## Main Modification 20 - Index by ID Number

## Site Allocations DPD: Main Modifications Response

DM/20/4692  
Land behind St Stephen's Church,  
Hamsland, Horsted Keynes

Review of Swept Path Analyses and Landholding – Rev 2

# Photograph – Tree & Hedge Location

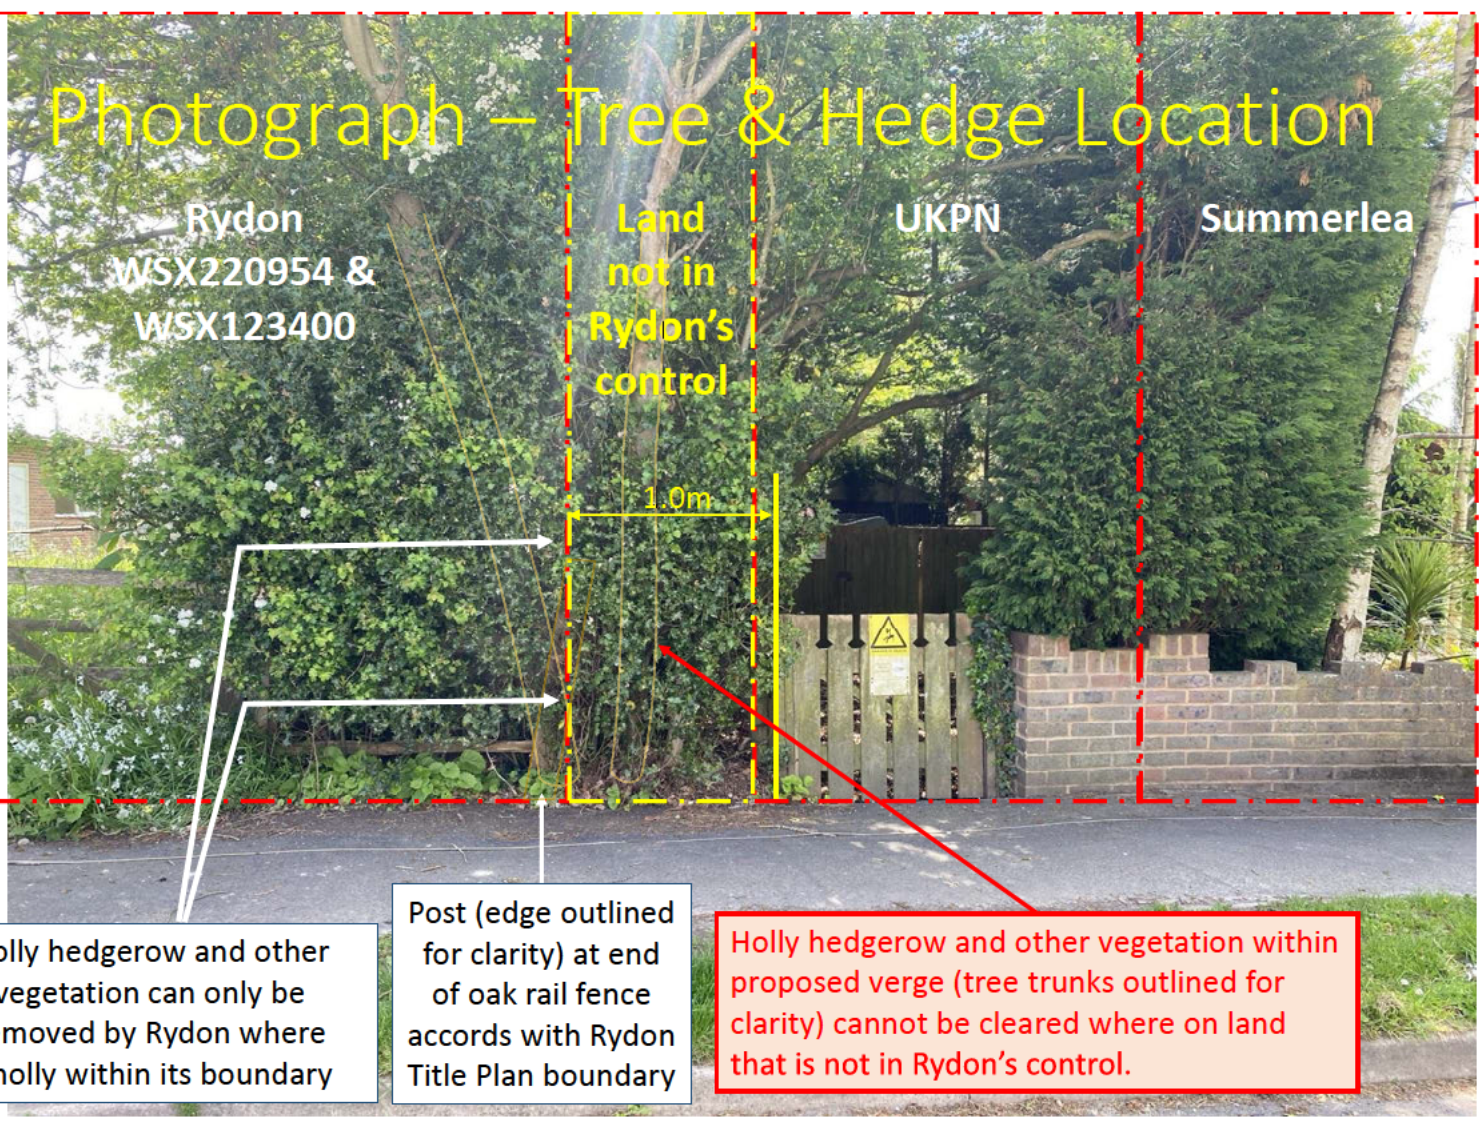
Holly hedgerow and other vegetation can only be removed by Rydon where wholly within its boundary

Post (edge outlined for clarity) at end of oak rail fence accords with Rydon Title Plan boundary

Holly hedgerow and other vegetation within proposed verge (tree trunks outlined for clarity) cannot be cleared where on land that is not in Rydon's control.

# Photomontage – Rydon

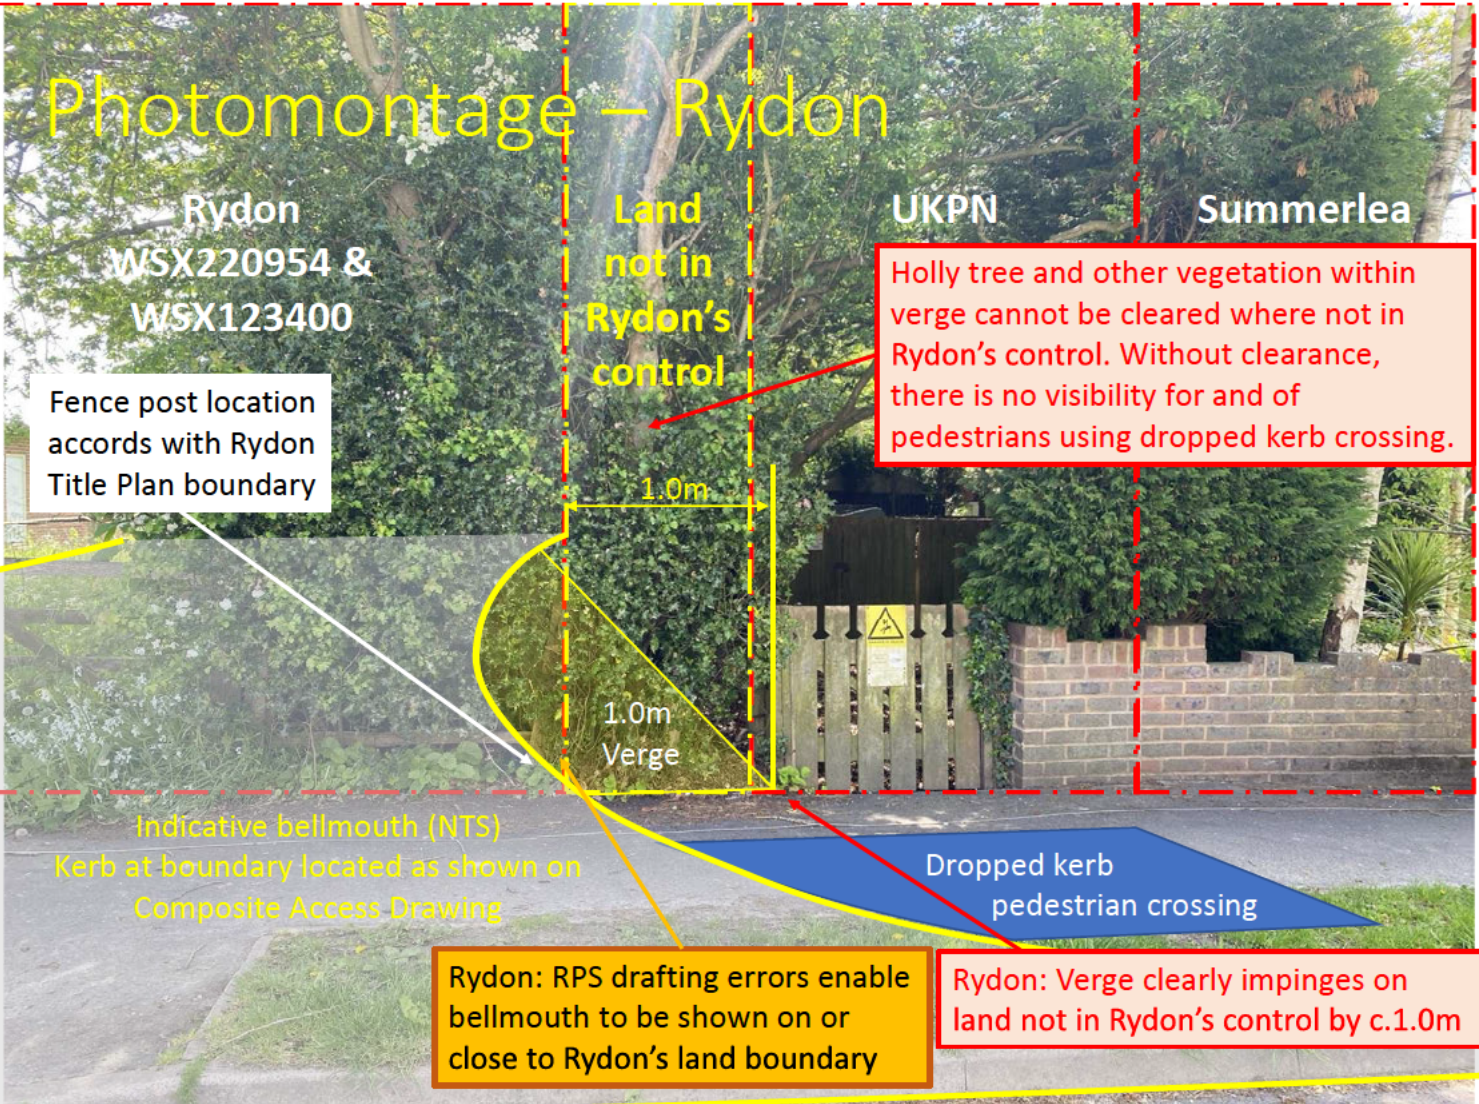
Holly tree and other vegetation within  
verge cannot be cleared where not in  
Rydon's control. Without clearance,  
there is no visibility for and of  
pedestrians using dropped kerb crossing.

Rydon: RPS drafting errors enable  
bellmouth to be shown on or  
close to Rydon's land boundary

Rydon: Verge clearly impinges on  
land not in Rydon's control by c.1.0m
